CUMBERLAND PLANNING BOARD MEETING MINUTES
August 15, 2023

1. Public Hearing: Site Plan Review of an eight space parking area for access to Rines Forest to be located at 48 Blanchard Rd., Tax Assessor Map U12, Lot 6.

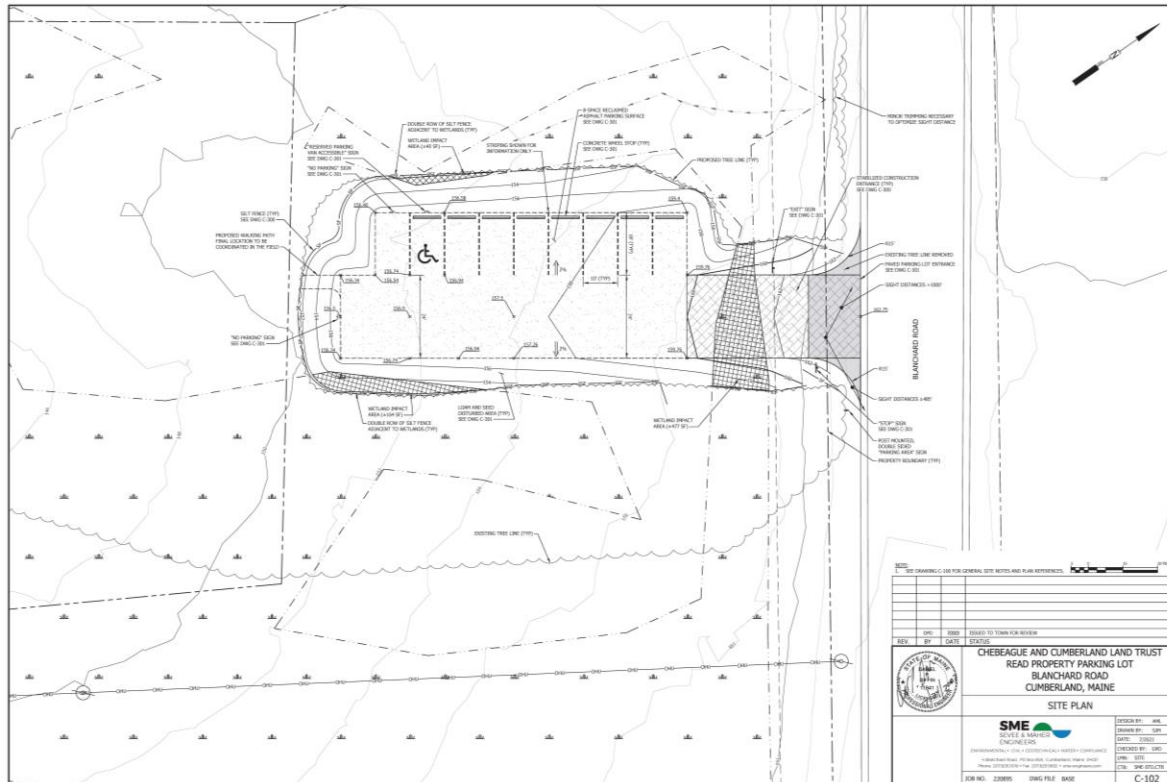
Mr. Auclair said the application lists 58.98 acres and in other areas indicates 53 acres. Mr. Read said it is 53 acres. Mr. Auclair noted that the IF&W application has 9 parking spaces. Mr. Read said it is 8 spaces and the 9th space is reserved for ADA van access.

Ms. Perry said she believes the speed limit in this area is 25 mph but the application shows that the speed limit is 35 mph. Mr. Read said the speed limit changes to 35 mph prior to this location. Ms. Perry said she is pretty sure it is 25 mph here and noted that she lives in the area. Ms. Perry acknowledged the speed limit does not impact the application but she would like to have the speed limit confirmed for the public record.

Abigail Cram, 47 Blanchard Rd., said vehicles speed through this area and there will be a lot of rear endings happening here. Ms. Cram requested that there be proper signage and clearly marked speed limit signs. Ms. Cram said she is thrilled to have this in

Dave Potter, owner of abutting lot, asked how people will get from the parking area to Rines Forest. Ms. Asherman said there will be a trail. The trail will go through the woods along the property line and connect to the third bridge at the waterfall trail. Mr. Potter said this will go along his property and he is concerned with people going onto his property. Ms. Asherman replied that there will be a buffer between the demarcated trail and the property line.

Mr. Potter asked for confirmation of the location of the trail through the woods. Mr. Read pointed out the location of the trail on the displayed plan.
